Access Compliance Report

Public Rights-of-Way

Intersection ID: 54154	Main Street: DEWEY_CREEK_LN	Cross Street: MAPLE_CREEK_CT	Location: NE
ADA ID: 9B9076CF008E	Ramp Type: Perp	Initial Pass/Fail: Pass	Overall Compliance: No
Severity Score: 15			
Codes/Mitigation Info/Possible Solution		Field Measurements/Component Compliance

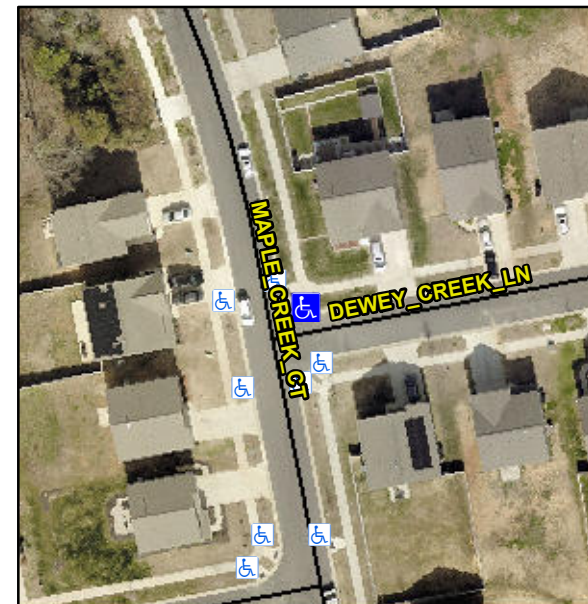
R305.2, R302.7.2, R304.5.3

Compliance	Description	Data	Compliance	Description	Data
N/A	Ramp Length (in)	93.5	Yes	Ramp Slope (%)	5.8
Yes	Ramp Width (in)	59.0	Yes	Ramp XSlope (%)	0.6
N/A	Flare Type LT	Sloped	N/A	Flare Type RT	N/A
N/A	Flare Slope LT (%)	9.3	N/A	Flare Slope RT (%)	9.2
N/A	Flare Traversable LT?	Yes	N/A	Flare Traversable RT?	No
Yes	Landing Length (in)	60.0	Yes	DWS Provided?	Yes
Yes	Landing Width (in)	62.0	Yes	DWS Contrast?	Yes
Yes	Landing Slope (%)	0.8	Yes	DWS Length (in)	24.0
Yes	Landing X Slope (%)	0.8	Yes	DWS Full Width?	Yes
N/A	Landing Curb? (Y/N)	No	No	DWS Offset (in)	3.5
N/A	Shared Landing?	No			
Yes	Gutter Ponding?	No	Yes	Gutter Slope (%)	1.1
No	Gutter Lip Ht (in)	1.5	No	Gutter X Slope (%)	2.5
N/A	Painted X Walk1?	No	N/A	Painted X Walk2?	N/A
	X Walk 1 Direction	To S		X Walk 2 Direction	N/A
N/A	X Walk 1 Width (in)	N/A	N/A	X Walk 2 Width (in)	N/A
	X Walk 1 Slope (%)	1.7		X Walk 2 Slope (%)	N/A
	X Walk 1 X Slope (%)	1.9		X Walk 2 X Slope (%)	N/A

Remove & Replace Detectable Warning System. Remove & Replace Gutter.
